AGENDA REPORT

Planning and Zoning Commission Meeting

SUBJECT: PPUD24-0002: Ridley Village Court Planned Unit Development Preliminary Development Plan

Figure 4: Preliminary Improvement Plan

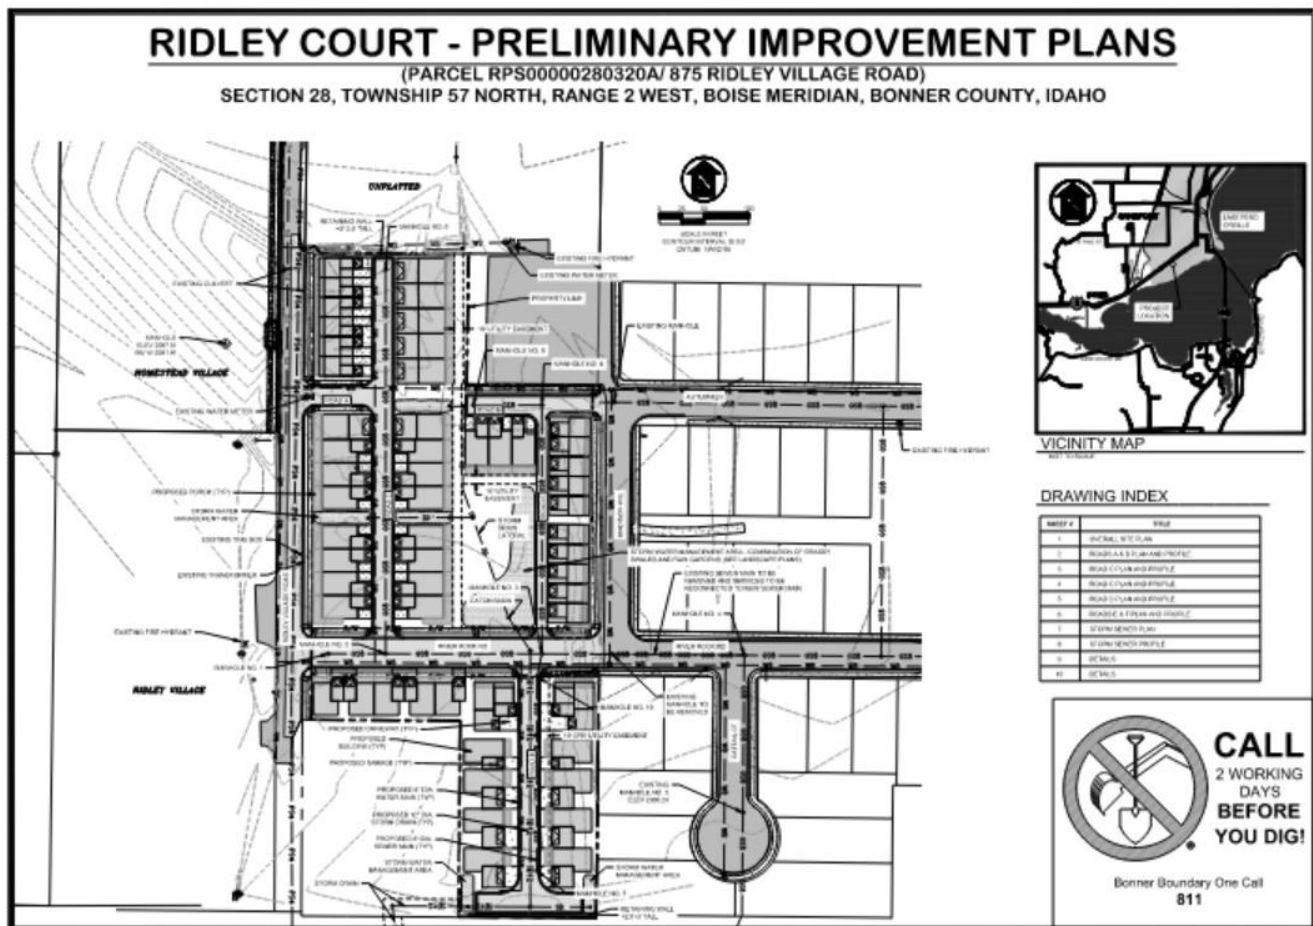
Proposed development does not comply. Private north-south driveways do not provide adequate width between buildings to provide the required easement width.

Staff Recommends revising development plan to provide rounded property corners at intersections, complying with all required setbacks.

Townhouse unit at the southeast corner of River Rock and Ridley Village, as shown on the submitted improvement plans, appears not to meet this provision.

Staff Recommends revising the development plan to allow adequate room for water and sewer main extensions.

3. Driveway for the townhouse units at the southeast corner of River Rock and Ridley Village, as shown on the submitted improvement plans, shall be located at least 35 feet from the proposed curb line along Ridley Village Road, pursuant to Sandpoint City Code 10-1-6-F.

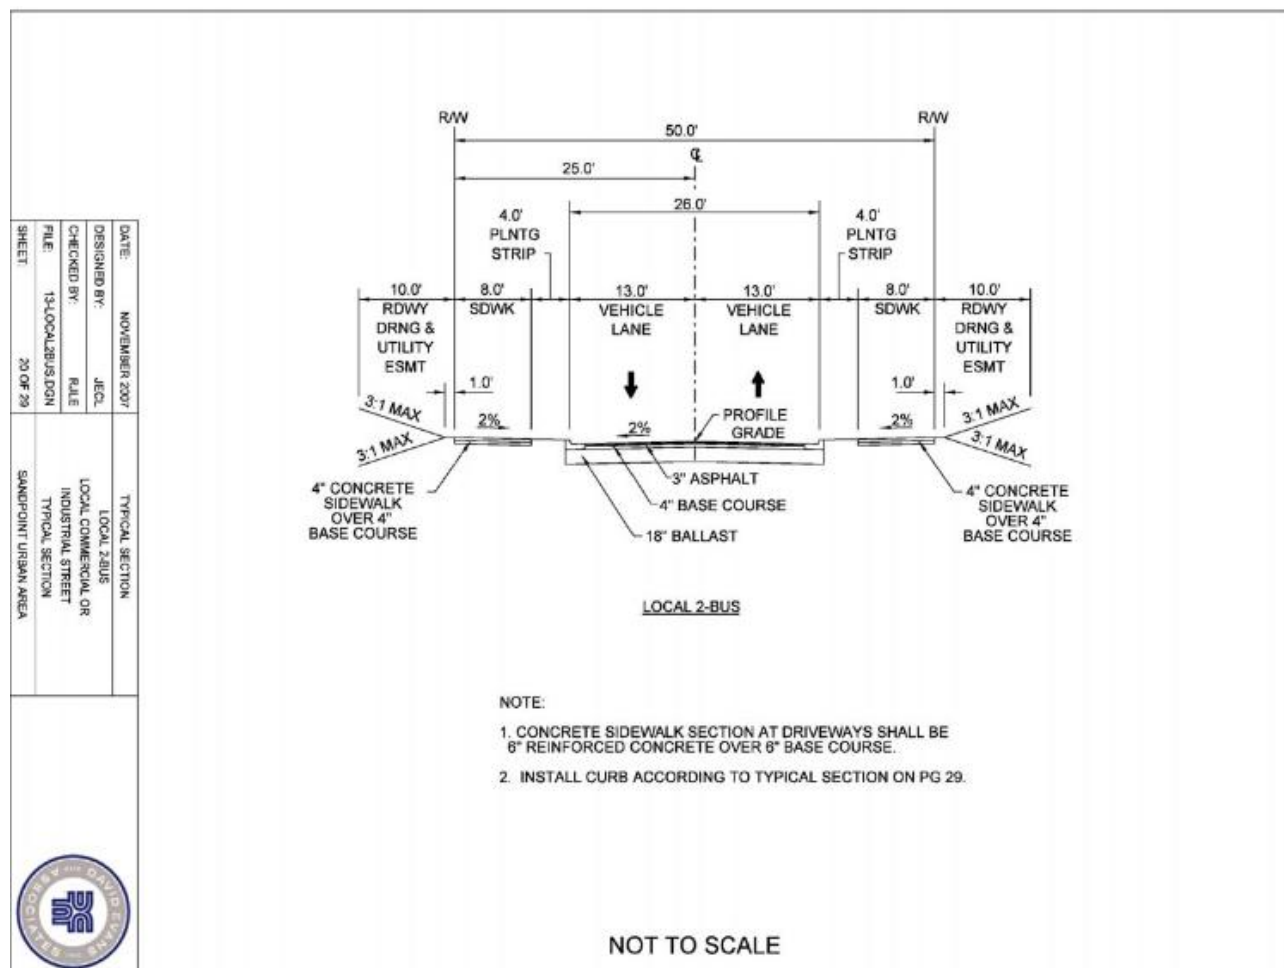
Typical section 4.3 on sheet 9 shows 31-foot pavement width from lip of curb to lip of curb, with 5-foot sidewalks on both sides.

Staff Recommends revising typical section 4.3 on sheet 9 of the improvement plans to show 29-foot pavement width from lip of curb to lip of curb (Two 11-foot travel lanes, one 7 foot parking lane on the north side). Provide “no parking” signs on south side of River Rock. Extension of Autumn Lane should show a similar section.
